DIFFICULTIES WITH LARGE BUBBLE CHAMBERS

W. D. Walker
University of Wisconsin

In this report I consider various difficulties associated with large bubble chambers and in particular the 25-foot bubble chamber as proposed by the BNL group. The classes of problems considered are:

Fig. 1. Optics of a bubble chamber: p is the lens to object-plane distance, d is the depth of field.

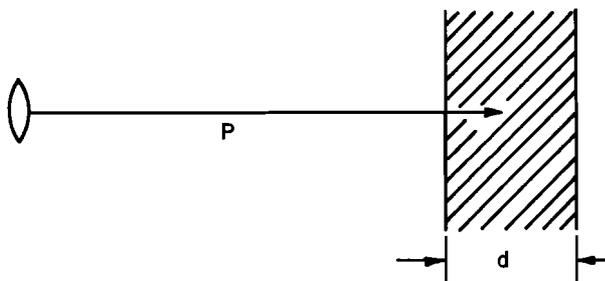
My objections to the present design almost always have as their root the optical considerations. The ultimate test of any chamber is one's ability to get useful pictures out of it. Let's compare the optical situation in a conventional chamber and the proposed system, as shown in Fig. 1; p is about 2 m, d is 0.5 m. The deviation δp from the plane of best focus is ± 0.25 m; thus $\delta p/p \approx 1/8$.

Fig. 2. Intensity distribution in a (diffraction-limited) bubble image.

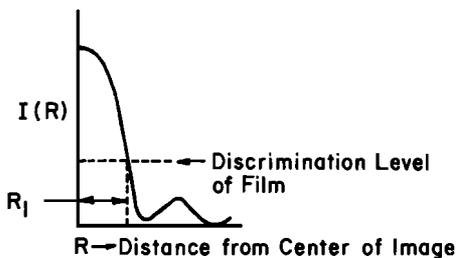
Diffraction effects and the film nonlinearity also help. In the plane of best focus the bubble produces a bright spot on the film, the angular radius of which is $\theta = 1.2 \lambda/a$. The radius R of the bubble image on the film is then (see Fig. 2)

$$R = 1.2 \lambda (q/a) \\ \approx 1.2 \lambda (F),$$

Fig. 5. Focusing of a pressure pulse by reflection from a spherical surface.

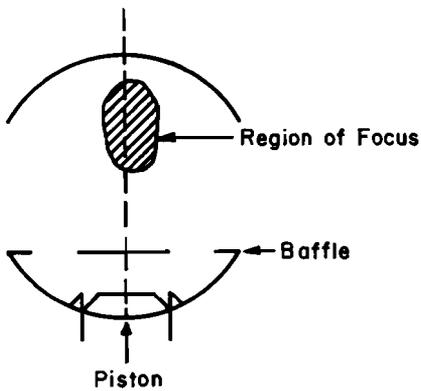
In a conventional chamber it is probably possible to see some ringing effects in the pressure trace. With the super chamber the velocity effects are very large. The time required for a pressure front to propagate across the chamber is 5 milliseconds. There are differences of distances from the center to the extremes of the chamber of the order of 2 or 3 meters. This means that there will be sizeable pressure differences between parts of the chamber. With an expansion time of 20 msec and a pressure drop of 40 psi, $dp/dt = 2$ psi/msec. Thus one would expect to find Δp 's of 2 - 4 psi from center to the side of the chamber, and Δp of 8 psi from top to bottom in the course of the expansion. If the bubble density is to be uniform then the chamber should be given 2 - 3 msec to equilibrate. The spherical shape of the chamber can also produce peculiar reflection effects (see Fig. 5). The sources in the expansion process are a pair of concentric rings. The source rings will be imaged along a vertical axis through the center of the chamber. It is conceivable that the chamber might be overexpanded in this region with a resulting frothy region. Such a situation might well be disastrous since a region of froth would short circuit the expansion.
